# HISTORIC AND DESIGN REVIEW COMMISSION

November 04, 2020

**HDRC CASE NO:** 2020-474  
**ADDRESS:** 333 W LULLWOOD AVE  
**LEGAL DESCRIPTION:** NCB 6537 BLK 17 LOT 5&6  
**ZONING:** R-5, H  
**CITY COUNCIL DIST.:** 1  
**DISTRICT:** Monte Vista Historic District  
**APPLICANT:** Josephat Valdez  
**OWNER:** Josephat Valdez  
**TYPE OF WORK:** Window replacement, fenestration modifications  
**APPLICATION RECEIVED:** October 15, 2020  
**60-DAY REVIEW:** Not applicable due to City Council Emergency Orders  
**CASE MANAGER:** Rachel Rettaliata

DRAWING:  
PROPOSED  
ELEVATION

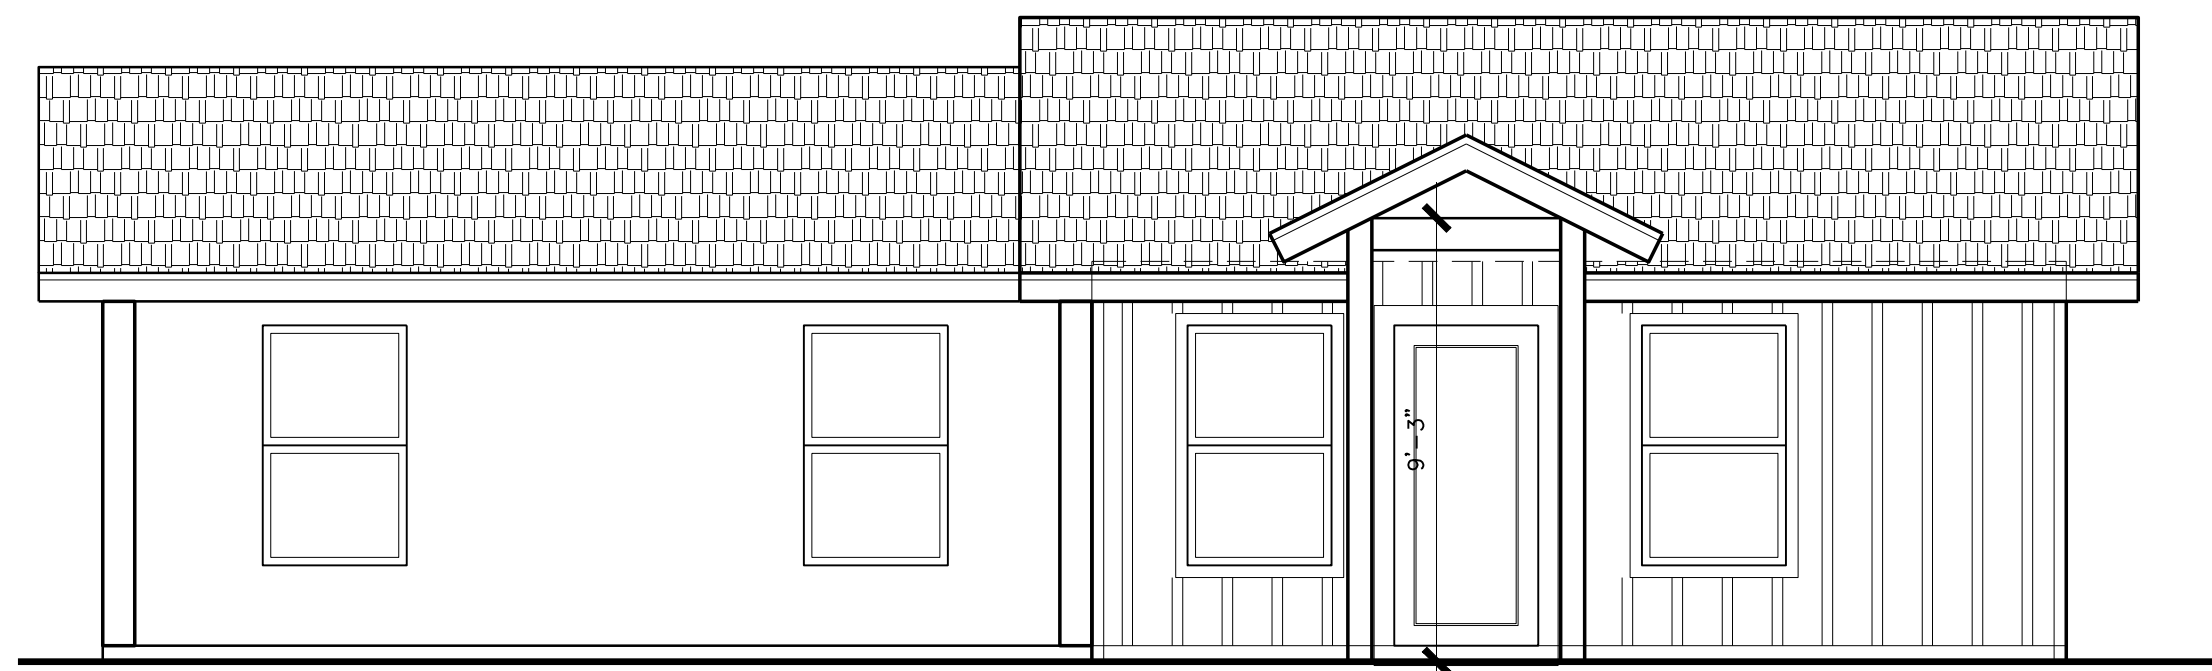
- c. **FENESTRATION MODIFICATIONS: EAST ELEVATION** – The applicant has proposed to replace windows G and I with Jeld-Wen W-5500 double slider windows and remove and enclose windows H and J in order to accommodate the size of the proposed replacement windows. Due to modifications to the interior layout, windows G, H, I, and J will be located in bathrooms. Guideline 6.A.i for Exterior Maintenance and Alterations states that existing window and door openings should be preserved. Avoid enlarging or diminishing to fit stock sizes or air conditioning units. Avoid filling in historic door or window openings. Staff finds that window G is a smaller sized window that could function well as a bathroom window and is in repairable condition. Staff finds that the request is inconsistent with the Guidelines.

- e. **WINDOW REPLACEMENT: WEST ELEVATION** – The applicant has proposed to replace a window on the west elevation with a smaller window (window Q) to accommodate a kitchen sink. Staff observed that window Q features broken cords and extensive wood rot. The applicant has proposed to install a 32-inch x 36-inch Jeld-Wen W-2500 double hung wood window. Guideline 6.B.iv states that new windows should be installed to match the historic or existing windows in terms of size, type, configuration, material, form, appearance, and detail when original windows are deteriorated beyond repair. Staff finds that the window is eligible for replacement but finds the proposal to modify the size of the opening to be inconsistent with the Guidelines.

- f. **WINDOW REMOVAL: WEST ELEVATION** – The applicant has proposed to remove window R on the west elevation to accommodate new kitchen cabinets. The applicant has proposed to remove window R and enclose the opening. Guideline 6.A.i for Exterior Maintenance and Alterations states that existing window and door openings should be preserved. Avoid enlarging or diminishing to fit stock sizes or air conditioning units. Avoid filling in historic door or window openings. Staff finds the proposal inconsistent with the Guidelines.

- g. **WINDOW REPLACEMENT: WEST ELEVATION** – The applicant has proposed to replace window S on the west elevation with a new door opening. The applicant has proposed to install a Jeld-Wen fully wood door. Staff observed that window S was in poor condition and featured extensive wood rot and missing frame elements. Guidelines 6.B.ii for Exterior Maintenance and Alterations states that applicants should ensure that new entrances, when necessary to comply with other regulations, are compatible in size, scale, shape, proportion, material, and massing with historic entrances. Due to the

Item 1, staff does not recommend approval of the request to replace 2 windows on the east elevation based on finding c.

Item 2, staff does not recommend approval of the request to remove and enclose 2 window openings on the east elevation based on finding c. Staff recommends that the applicant maintain the historic window openings.

Item 4, staff does not recommend approval of the request to replace the window on the west elevation based on finding e. Staff recommends that the applicant maintain the size of the historic window opening and installs a replacement window that meets the following stipulation:

Item 5, staff does not recommend approval of the request to remove and enclose the window opening on the west elevation based on finding f. Staff recommends that the applicant maintain the historic window opening.

Item 6, staff recommends approval of the request to modify the existing window opening on the west elevation to accommodate a door installation based on finding g with the following stipulations:

- i. That the applicant submits final material specifications for a fully wood door to staff for review and approval prior to the issuance of a Certificate of Appropriateness.
- ii. That the applicant receives approval for any side porch and/or decking installation prior to installing the new door opening.

PROPOSE  
FLOOR PLAN

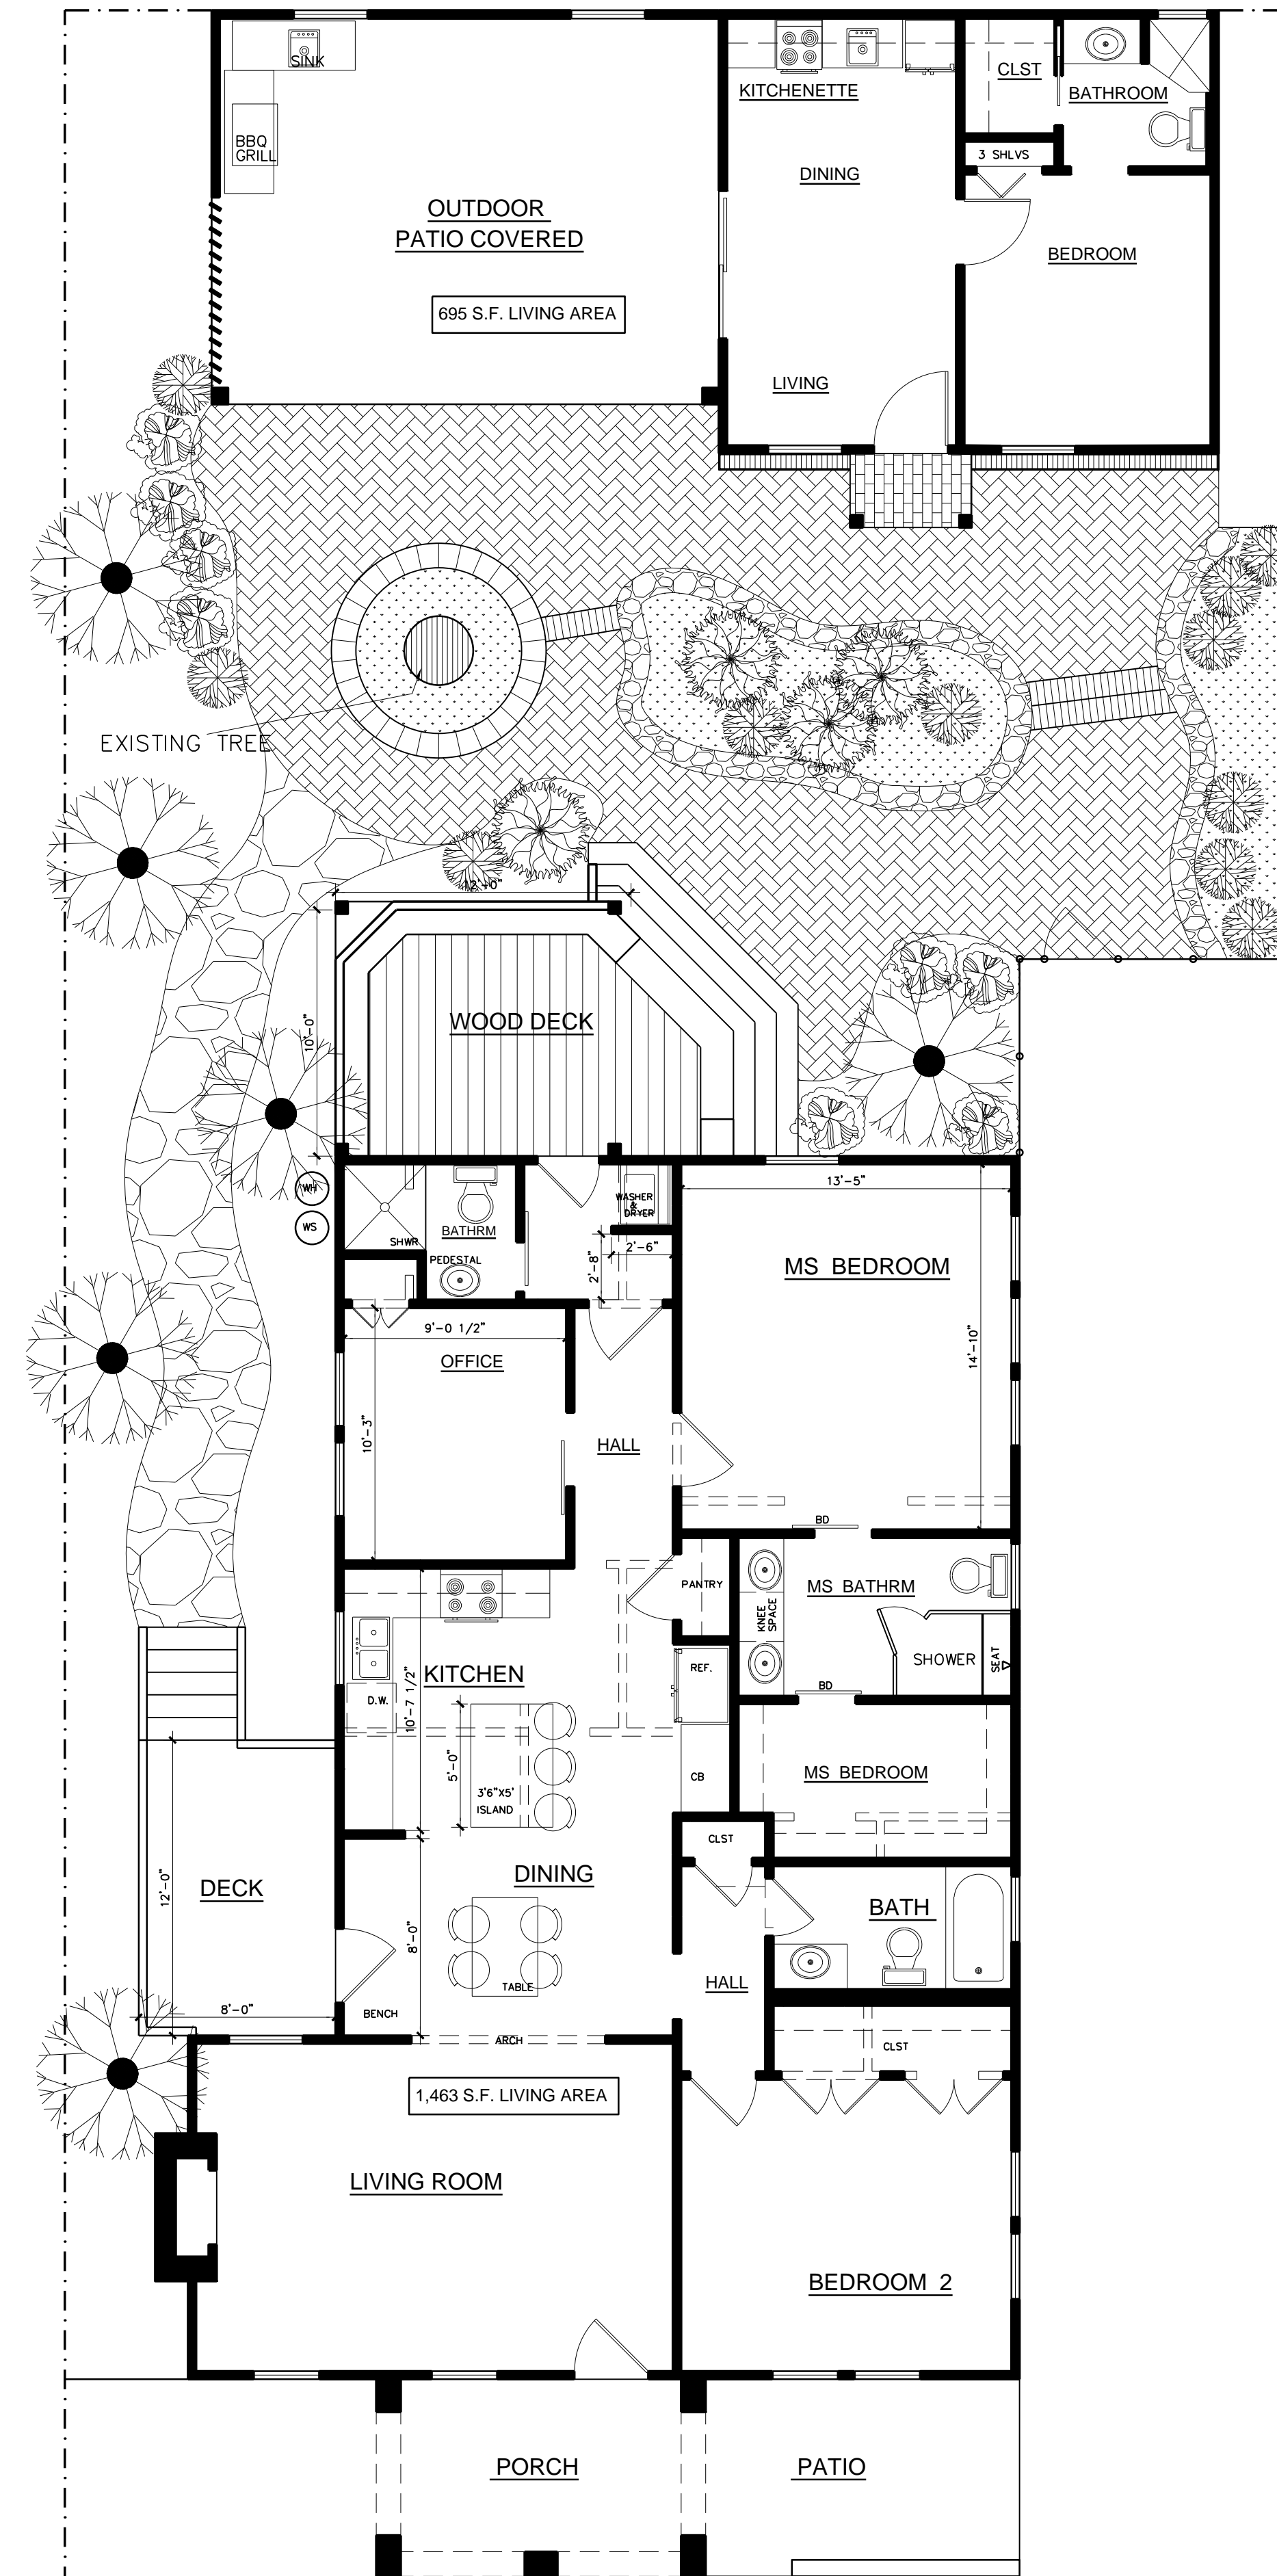
- d. **WINDOW REPLACEMENT: REAR ELEVATION** – The applicant has proposed to remove the non-original aluminum window on the rear elevation (window N) with a window salvaged from the east elevation. According to Guideline 6.B.vii, replace non-historic incompatible windows with windows that are typical of the architectural style of the building. Staff finds the proposal appropriate.

Item 3, staff recommends approval of the request to replace the rear window based on finding d. Due to staff's recommendation against removing the windows on the east elevation, staff recommends that the applicant replace the rear window with a window that meets the following stipulation:

- i. That the applicant installs a fully wood window that meet staff's standard window stipulations and submits updated specifications to staff for review and approval. The windows should feature an inset of two (2) inches within facades and should feature profiles that are found historically within the immediate vicinity. Meeting rails must be no taller than 1.25" and stiles no wider than 2.25". White manufacturer's color is not allowed, and color selection must be presented to staff. There should be a minimum of two inches in depth between the front face of the window trim and the front face of the top window sash. This must be accomplished by recessing the window sufficiently within the opening or with the installation of additional window trim to add thickness. Window trim must feature traditional dimensions and architecturally appropriate sill detail. Window track components must be painted to match the window trim or concealed by a wood window screen set within the opening.
